UNITED STATES PATENT AND TRADEMARK OFFICE

10/602,547

Office Action Summary	Application No. 10/602,547	Applicant(s) BATEMAN ET AL.	
	Examiner Troy Chambers	Art Unit 3641

DETAILED ACTION

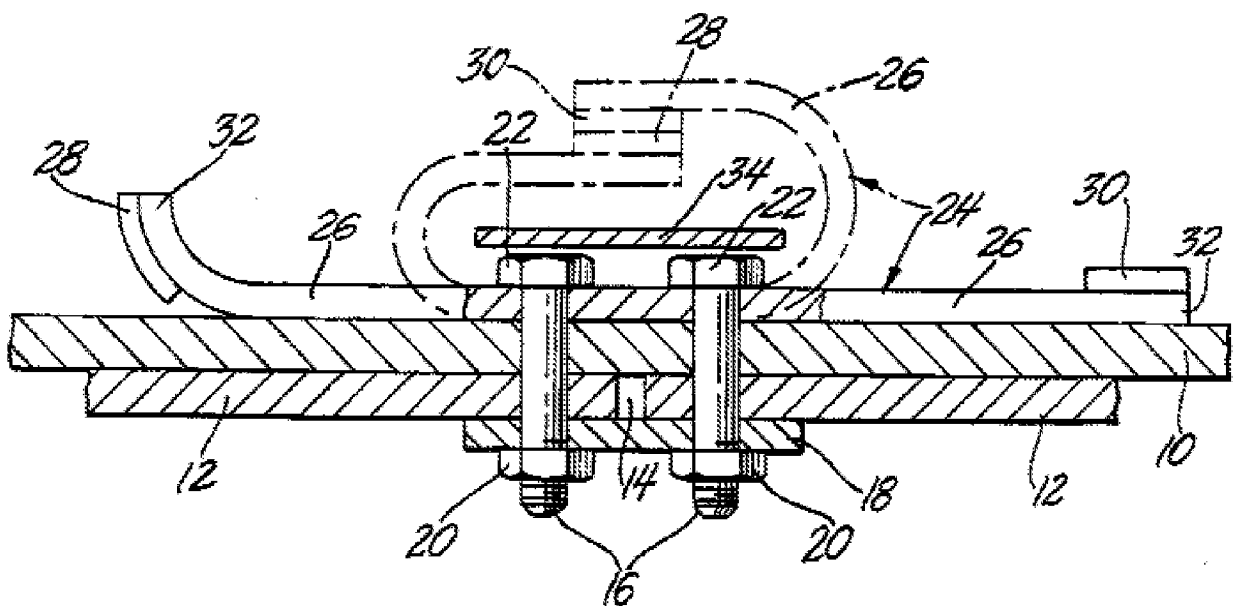
22. Claims 12, 13, 16, 17, 21, 22, 36, 37, 38, 39, 50 and 51 are rejected under 35 U.S.C. 102(b) as being anticipated by Figure 7 of US 5822936 issued to Bateman.

23. With respect to claim 12, Bateman discloses two pieces of plate steel 210; facing strip 214; mounting bracket 238; bolt and nuts 222, 234; and, bullet containment frame 250, 264, 268. At col. 7, lines 31-32, Batement describes the connection of the nut and bolt as follows: "A bolt 222 extends from the facing strip 214 through the hole 218 in the backing strip 230." This disclosure says nothing about the bolt extending through the containment frame (250, 264, 268). Therefore, the attachment of the bolts to the facing strip and mounting bracket is not dependent upon the attachment of the containment frame which is apparently attached by some other method.

24. With respect to claim 13, Bateman discloses wood post 250 which is attached to the facing strip which is attached to the steel plates which is attached to the bracket. Therefore, the wood post is attached to the mounting bracket.

25. With respect to claim 16, Bateman discloses a wood post 250. The manner of making the post is of no consequence to an apparatus claim.

26. With respect to claim 17, Bateman discloses mounting bracket arm 238.

27. With respect to claim 21, Bateman discloses a modular ballistic wall as discussed above with the backing strip identified at 230.

29. With respect to claims 36, 37, 38 and 39, refer to claim 12 where it was explained that the bolts 222 extended through the facing and backing strips and not the wood post 250. The wood post is attached to the facing strip 250 so it is inherently attached to the attachment mechanism.

30. With respect to claim 50, an altered but valid interpretation of Bateman is necessary. In this case, the plurality of steel plates are the same, namely elements 210. The facing strip is 230 but the mounting bracket is now identified at 250. The plurality of sheets is 264, 268 and it can be seen that the mounting bracket separates the sheets from the strip. Bullet deceleration medium can be found at 260.
